New Ave Bikeway Section D District Connector

Preliminary Design Report May 2023

Project:	Takoma COGTL	C New Ave Section D	
Date:	March 2023		
Reviewer:	City of Takoma	Park	
Comment ID	Sheet No. / Drawing No.	Comment	Response
1	HD-01	Can you clarify if the intention is to remove parking on either side of the street? If parking is to be removed from one side or another, there is an interest in removing it from the north side of the street (already limited)	Parking is only available on one side of the street and the intention is to keep this parking. Parking on the other side violates the minimum offsets from crosswalks, driveways, etc.
2	HD-01	There is a utility pole here that currently makes this very ADA in-accessible. Can you confirm in this new design whether this would become ADA accessible?	We are proposing to relocate this utility pole.
3	HD-02	Is it possible to re-design this to be a better speed bump? Right now it has a double-bump that is unpleasant for all users. Are there designs that would be more bike compliant?	We have replaced the Takoma Park standard speed humps with more bike friendly Montgomery County standard speed humps.

Figure 3 - Takoma Park Speed Hump Profile

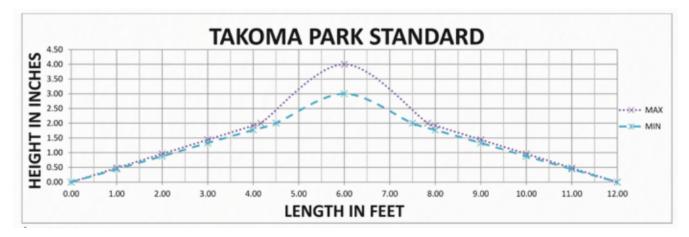
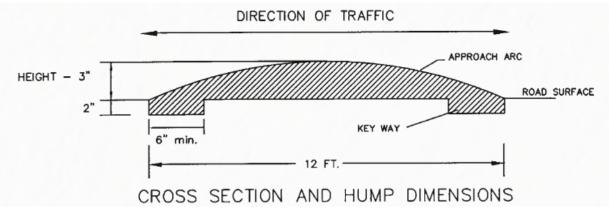
6	General	Speed humps installed in the City of Takoma Park can be quite disruptive to bicycle travel on shared streets. Recommend that speed humps be evaluated for bicycle use and re-designed to conform to MCDOT design standards for similar county roads. Locations - 4th Avenue between Poplar Avenue and Cockerille Avenue and 4th Avenue between Orchard Avenue and Allegheny Avenue. An alternative would be to modify the existing speed humps to provide cutouts for bicyclists.	We have recommended that speed humps be converted to more bike-friendly MCDOT speed humps.
7	5,6	Were alternative routes to the Eastern Avenue/Kansas Lane intersection considered for the bike route? Why not use 4th Avenue to Eastern, and then construct a sidepath along the north side of Eastern avenue to Kansas lane?	This route has a significant difference in elevation climb. DPW reviewed the alternative routes considering aspects such as elevation climb and ROW and determined the route shown is preferred.
